# COVENANT DEFERRAL REQUEST

**FOR THE PROPOSED TITLE TRANSFER  
OF THE FORMER POWERHOUSE, DUCT ISLAND,  
AND K-1007-P1 POND AREA AT THE  
EAST TENNESSEE TECHNOLOGY PARK,  
OAK RIDGE, TENNESSEE**

**DRAFT FOR PUBLIC REVIEW**

**February 2016**

Figure 3. Exposure Units in the Former Powerhouse Area, Duct Island, and K-1007-P1 Pond Area

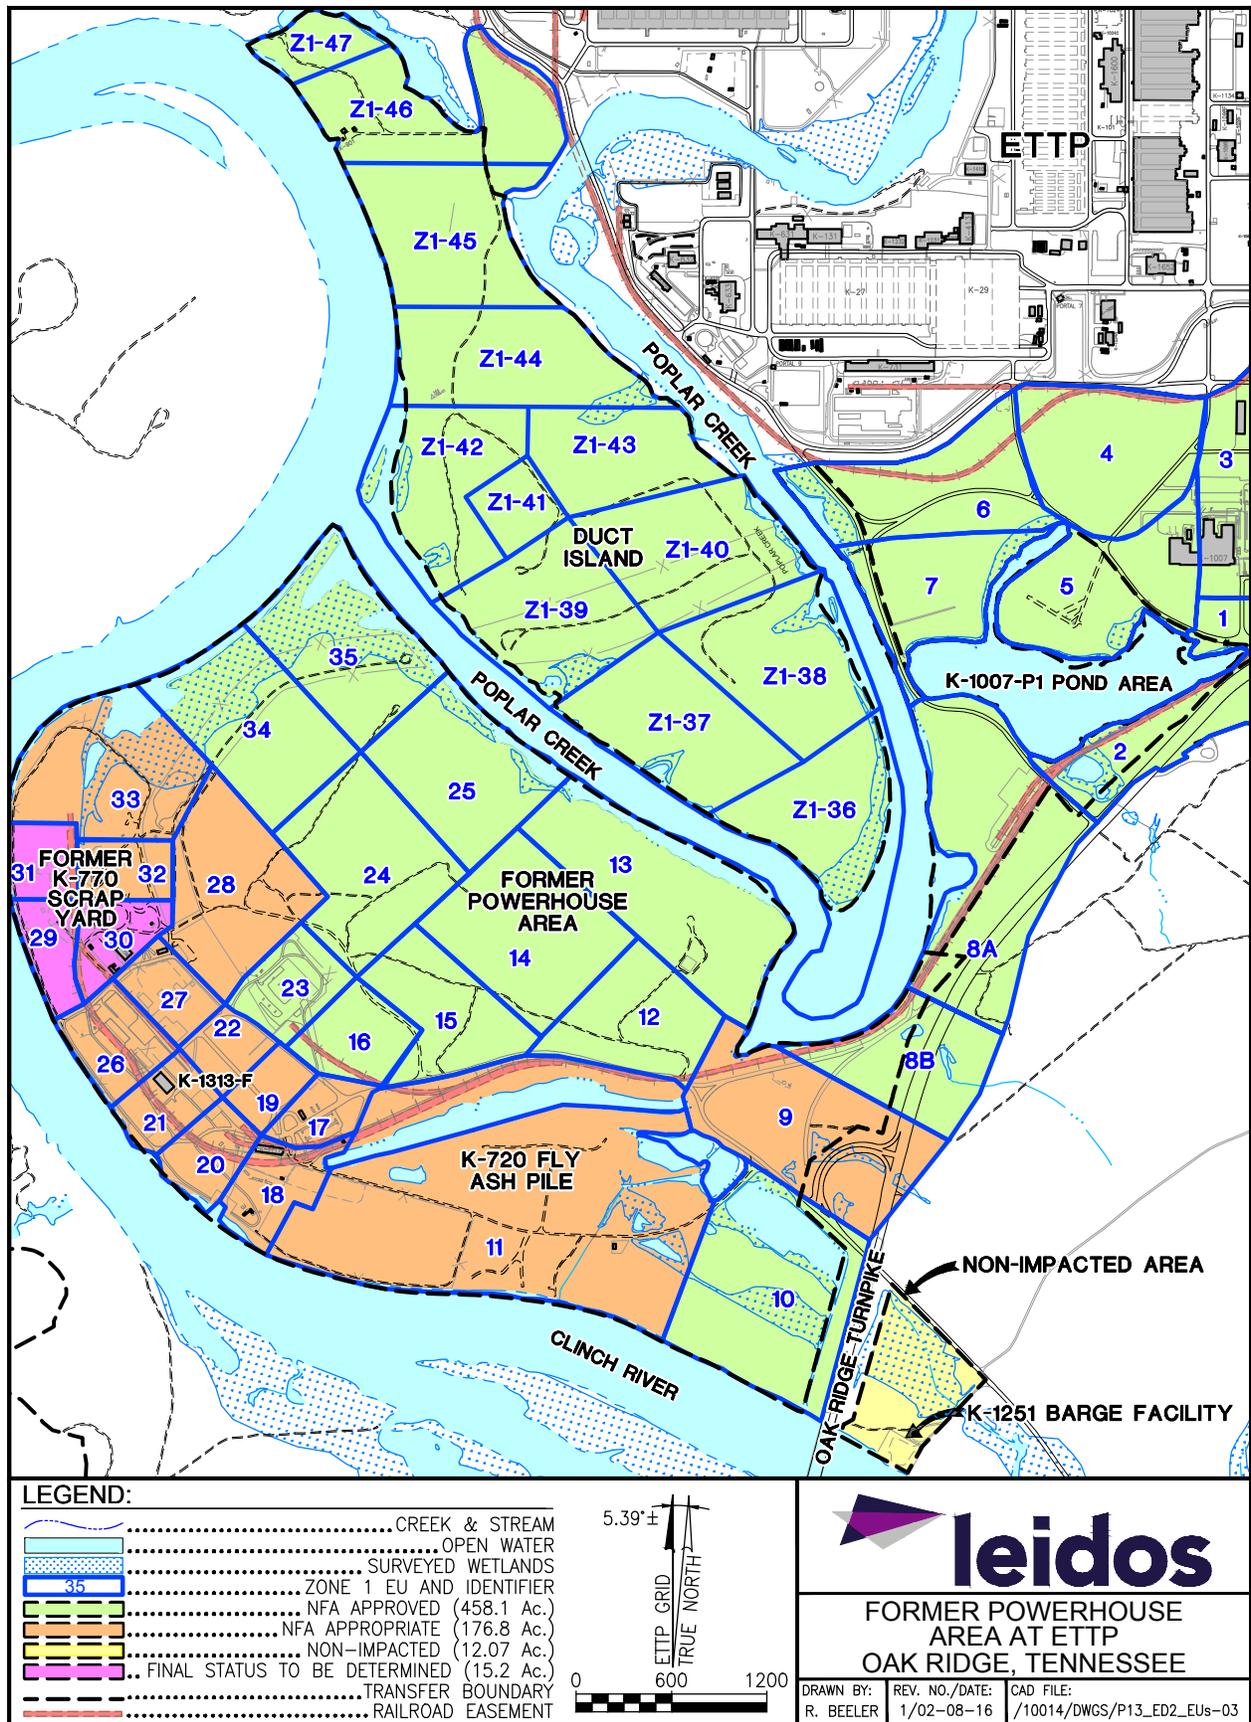
5. Page 4, Ecological Impacts: The language regarding ecological receptors on Page 5 should mention that the final ETTP Sitewide ROD will address ecological risks from constituents in sediments as well as surface water and groundwater. The surface water and sediments of the Beaver Dam Ponds were deferred to the final ETTP Sitewide ROD, Section 1.0, page 6 and Figure 3: Some of the dashed line that shows the boundary(ies) of the transfer footprint appears to be obscured by a solid blue line. Please address.

**DOE RESPONSE:** *The language regarding ecological receptors has been revised to indicate that ecological risk from sediments will be addressed in the ETTP Sitewide Final ROD. Figure 3 has been revised as best that can be done to account for overlapping boundaries.*

Figure 6. Former Powerhouse Area, Duct Island, and K-1007-P1 Pond Area Monitoring Well Locations

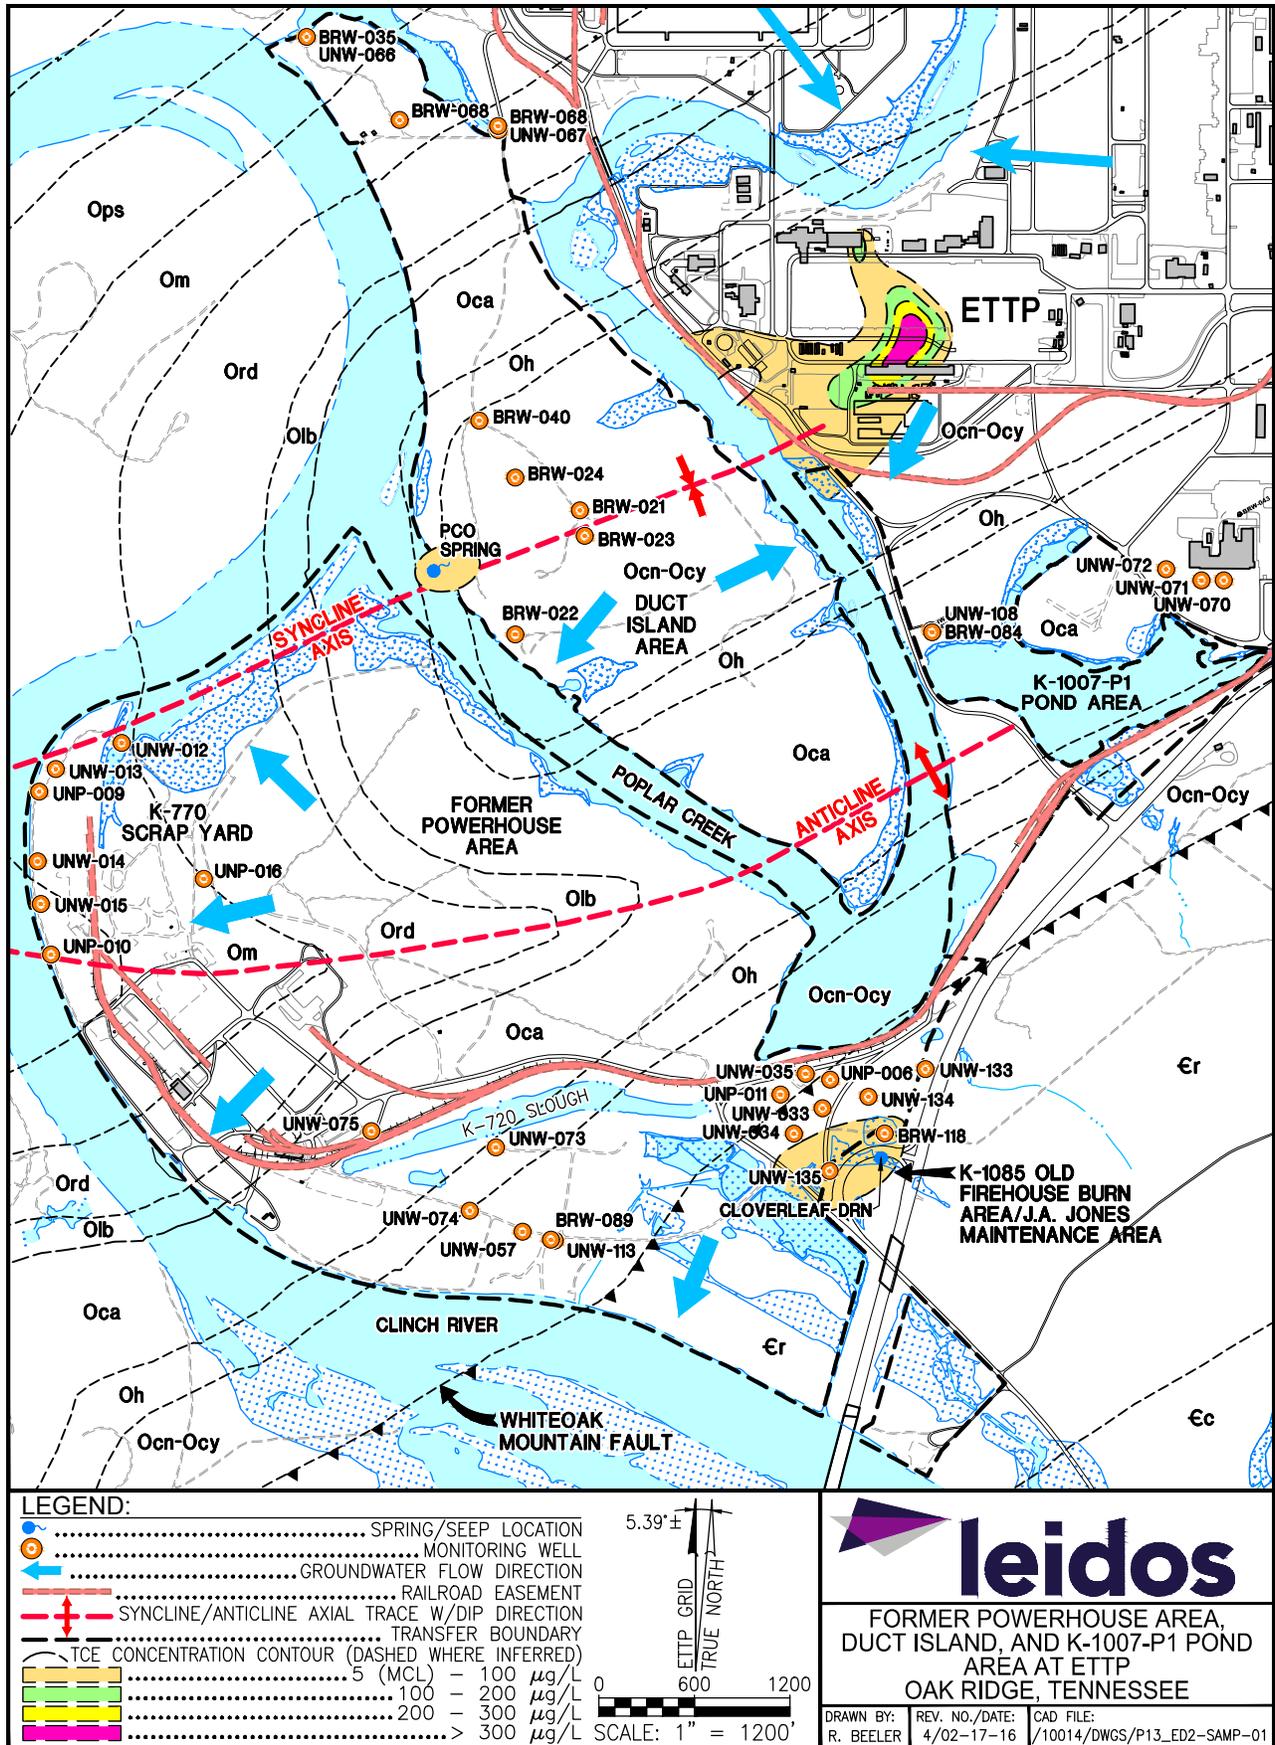
14. Page 16, Figure 6: The groundwater in the area is not fully delineated vertically or horizontally. Please extend the plume to include the PCO spring. Also, please ensure the plume boundary is dashed unless there is sufficient data to confirm the boundary is known exactly.

**DOE RESPONSE:** Figure 6 has been revised to indicate a small area of contamination at the PCO spring, but the existing data do not indicate a hydrogeological connection or relationship between the K-27 plume and the PCO spring.
